PCN 08P3			
Project No P 6403(10)	County Pennington	Contract Amt	\$23,381,920.13
Type of Work Grading, Drainage, Base Course, Asphalt Concrete Surfacing			
Contractor LOISEAU CONSTRUCTION, INC.

The following change in plans and/or specifications for the subject project is hereby made:

Parcel 18a Drainage

4' x 6' Junction Box Detail NIS

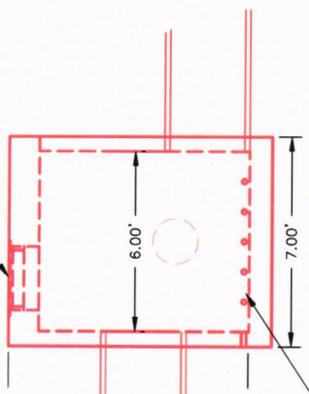
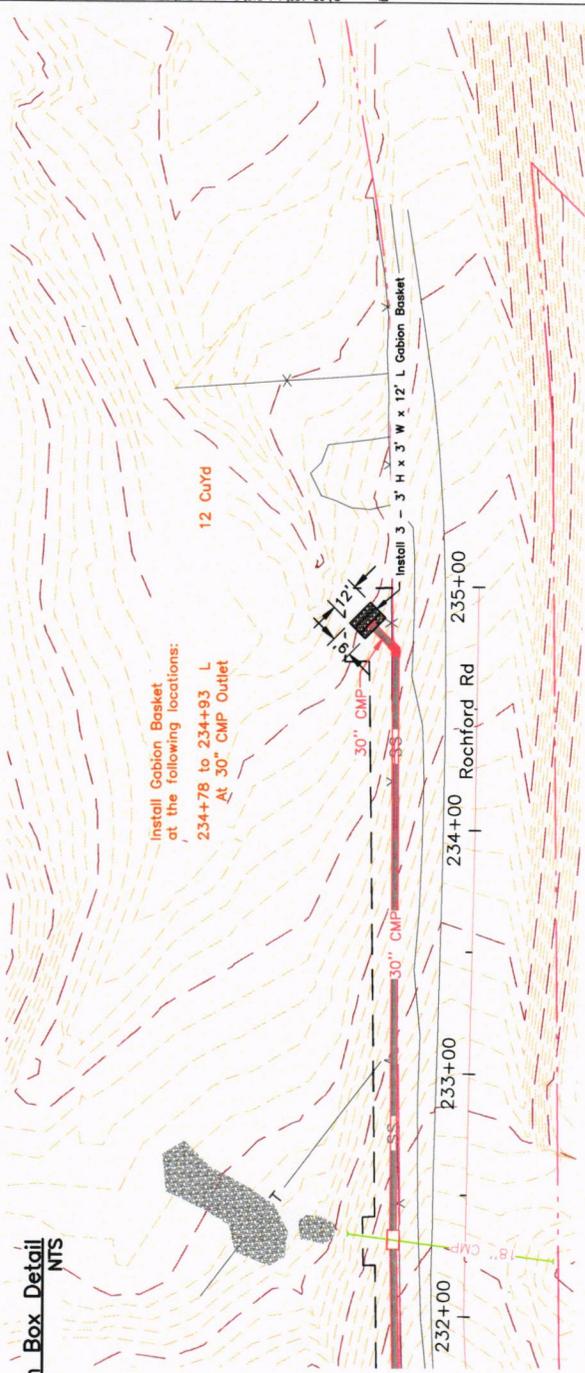
Instruction: The Contractor will install rock check dams, CMP storm sewer piping, precast drop inlets, ditch blocks and a gabion outlet structure as shown on the attached drawings. All costs to install the drop inlets will be included in Line No. 137P. All costs for constructing the ditch blocks will be included in Line No. 135P. The Contractor will also fill and grade the inslope on Parcel 18a between roughly Sta. 231+00 and 232+50 Lt after the pipe work is completed as directed by the Engineer. The fill material will come from the excavation generated from the pipe and inlet installation. All of the rocky material previously deposited on Parcel 18a from erosion that happened upstream from Parcel 18a will be removed. All costs to remove the rocky material, and fill and grade the inslope will be included in Line No. 134P. Concrete collars will be constructed to connect the pipe to the drop inlets as detailed on the attached drawing. Wire mesh will not be required in the collars. Class M6 concrete will be used for the collars. All costs to construct the collars will be included in Line No. 138P. The existing fence between roughly Sta. 230+85 and 235+30 Lt. will be removed to allow work to be completed and reset after the work is completed as directed by the Engineer. 15' of the fence will not be reset as the landowner wanted the beginning of the fence shifted to give better approach access. Approximately 25' of the existing cross pipe at Sta. 232+33 will need to be removed at the outlet end in order to install the new drop inlet at Sta. 230+41.3 Lt. and connect the pipe to it. All costs for removing this pipe will be included in Line No. 024P. All of the pipe and drop inlets will be furnished by the County. Base course will be placed on the approach at Sta. 230+78 Lt. after the new pipe installed across the approach. Once all work as described above is completed, all disturbed areas will be seeded and final stabilization installed. All costs to mobilize labor, equipment and materials to project to complete this work will be included in Line No. 132P.

Re-Grade Ditch
Sta 206+00 to Sta 230+50
per Typical Section
Sheet 26
P 6043 (10)

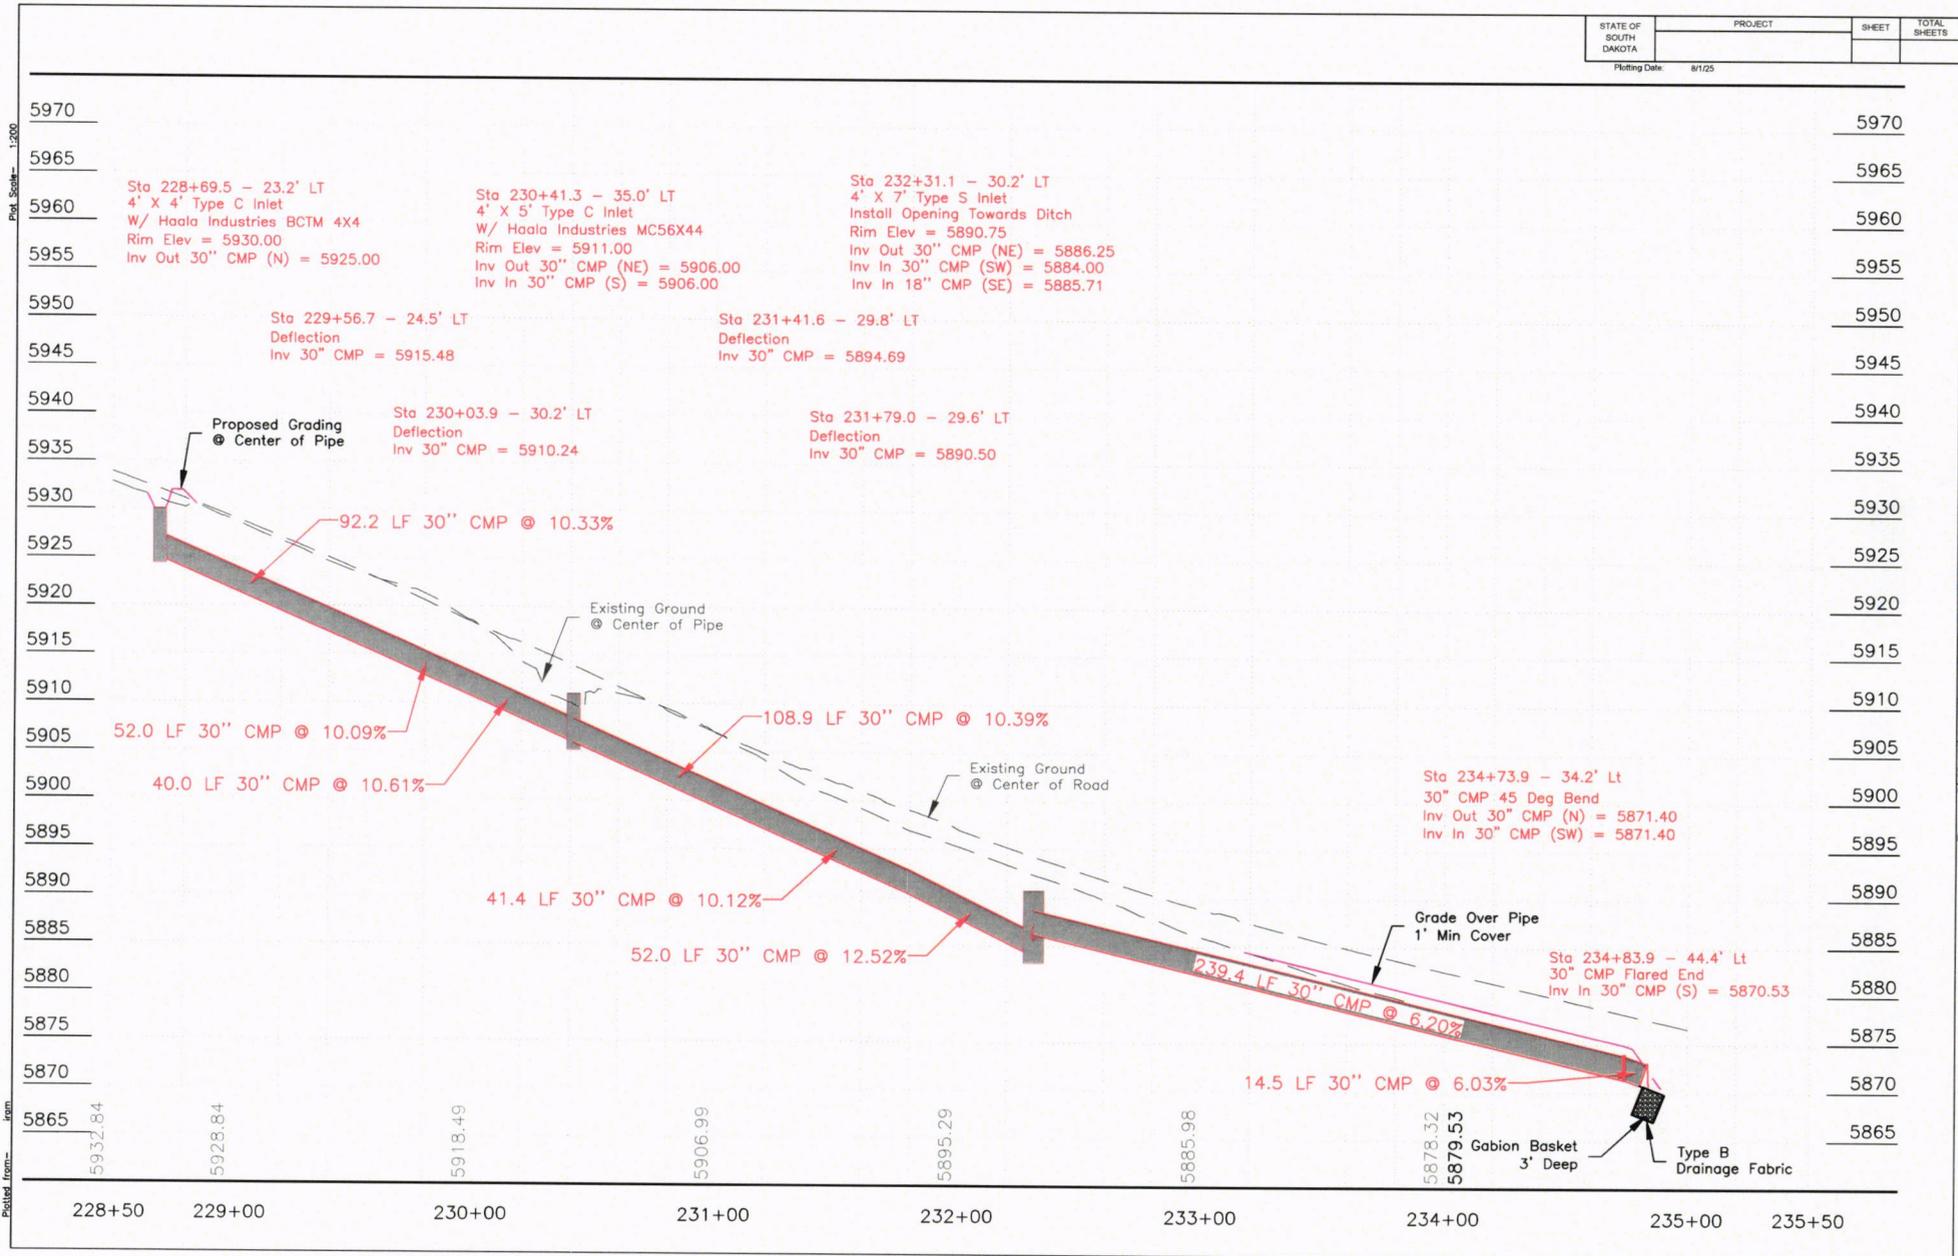
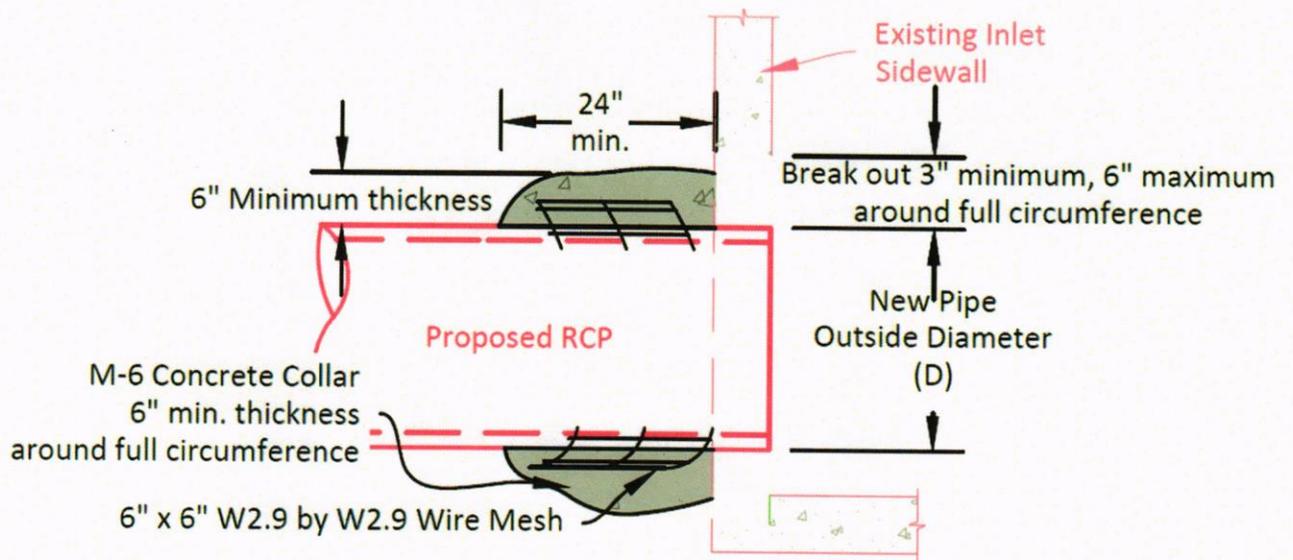
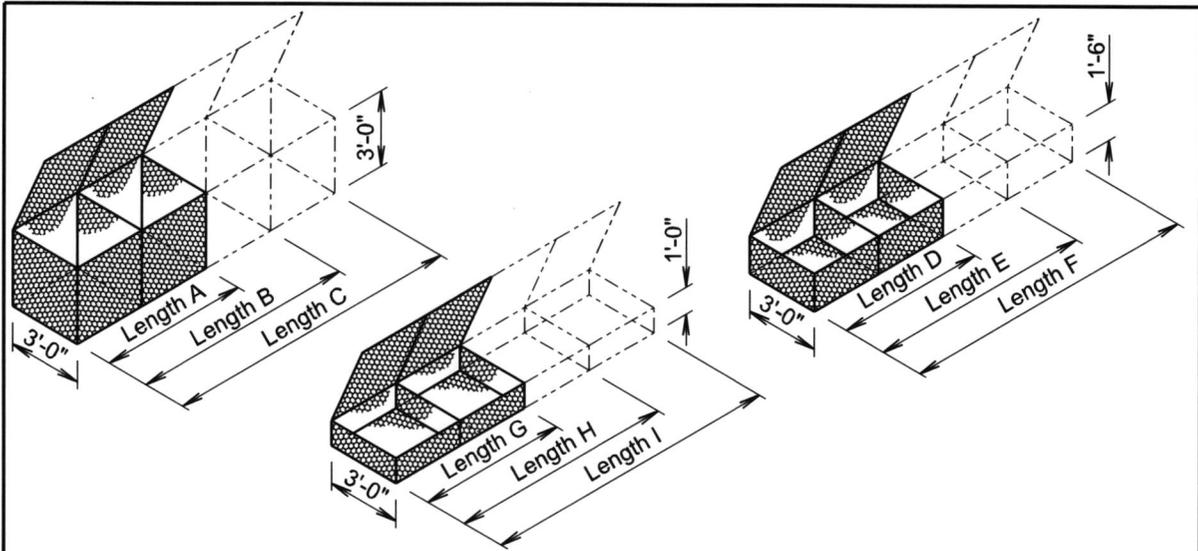
Reason: Due to the design of the new roadway and increased drainage, the as designed upstream ditch and approach pipe at Sta. 230+78 Lt. was insufficient to handle the volume of water coming down the ditch and hitting the approach. Through the duration of the project, this ditch and approach had been washed out several times and rebuilt to no avail. The eroded material would end up on the landowners property and would have to be removed each time. This would require disturbance of the vegetated ground and create a mess on the landowners property. The County contracted with a Consultant to evaluate this drainage and come up with a solution. After many iterations and several meetings with the landowner, the design on the attached sheets was what was agreed upon and approved to fix the drainage issue.

- Sta 228+69.5 - 23.2' LT 4' X 4' Type C Inlet.
W/ Haala Industries BCTM 4X4
- Sta 230+41.3 - 35.0' LT 4' X 5' Type C Inlet.
W/ Haala Industries MC56X44
- Sta 232+31.1 - 30.2' LT 4' X 6' Junction Box

- Sta 229+56.7 - 24.5' LT 30" CMP Deflection
- Sta 230+03.9 - 30.2' LT 30" CMP Deflection
- Sta 231+41.6 - 29.8' LT 30" CMP Deflection
- Sta 231+79.0 - 29.6' LT 30" CMP Deflection

- Sta 228+69.5 - 23.2' LT to Sta 229+56.7 - 24.5' LT Install 94 LF - 30" CMP.
- Sta 229+56.7 - 24.5' LT to Sta 230+03.9 - 30.2' LT Install 52 LF - 30" CMP.
- Sta 230+03.9 - 30.2' LT to Sta 230+41.3 - 35.0' LT Install 40 LF - 30" CMP.
- Sta 230+41.3 - 35.0' LT to Sta 231+41.6 - 29.8' LT Install 110 LF - 30" CMP.
- Sta 231+41.6 - 29.8' LT to Sta 231+79.0 - 29.6' LT Install 42 LF - 30" CMP.
- Sta 231+79.0 - 29.6' LT to Sta 232+31.1 - 30.2' LT Install 52 LF - 30" CMP.

Install Gabion Basket at the following locations:
234+78 to 234+93 L
At 30" CMP Outlet

- Sta 234+73.9 - 34.2' LT 30" CMP 45 Deg Bend
- Sta 234+83.9 - 44.4' LT 30" CMP Flared End

- Sta 232+31.1 - 30.2' LT to Sta 234+73.9 - 34.2' LT Install 240 LF - 30" CMP.
- Sta 234+73.9 - 34.2' LT to Sta 234+83.9 - 44.4' LT Install 16 LF - 30" CMP.
